Range HO.RE.CA.	Model KOMETA – LA BRILLANTE	N° T.I. 02_2024
Serial Number See page 2 / 2	Subject Liquid DRIP TRAY modification for liquid waste disposal KIT

KOMETA – liquid drip tray assembly

LA BRILLANTE – liquid drip tray with plugs assembly

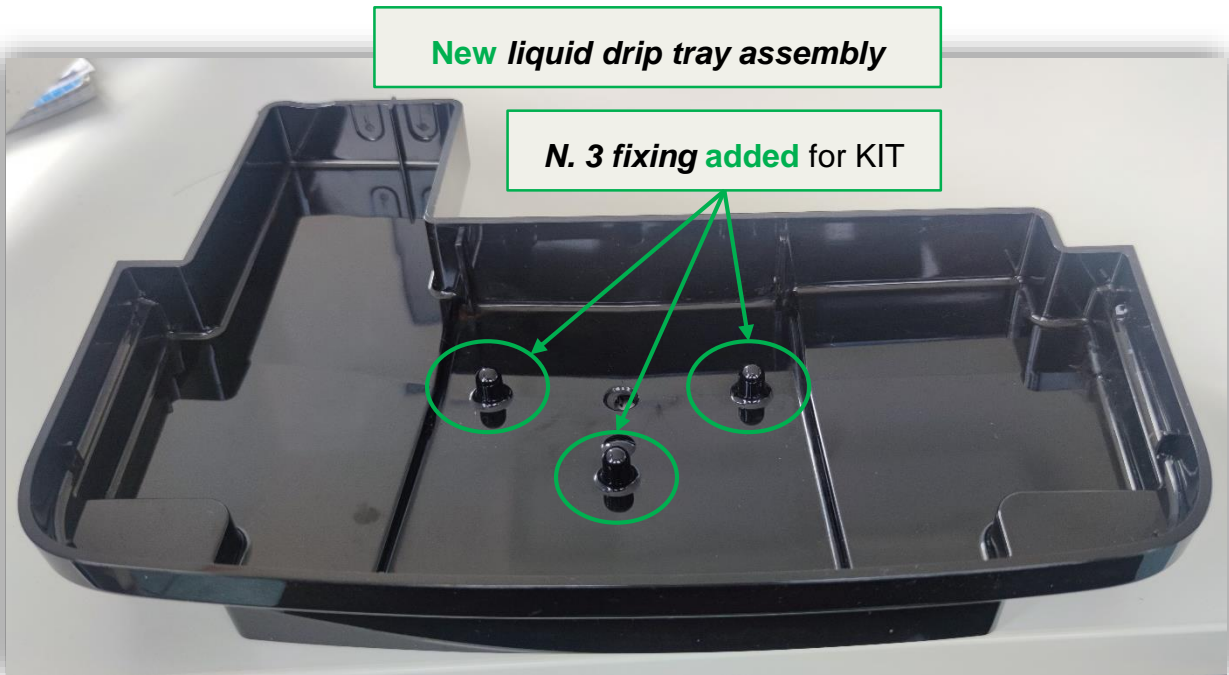
To allow the assembly of the *liquid waste disposal KIT* (code **9P0200**)

3 fixings have been added as shown below

- ✓ For machines produced starting from the **S/Ns** indicated above, the *liquid waste disposal KIT* (code **9P0200**) can be mounted without modifications.
- ✓ For machines produced before the S/Ns indicated above, the aforementioned **KIT** can be mounted by ordering the **new liquid tray assembly** codes indicated above.
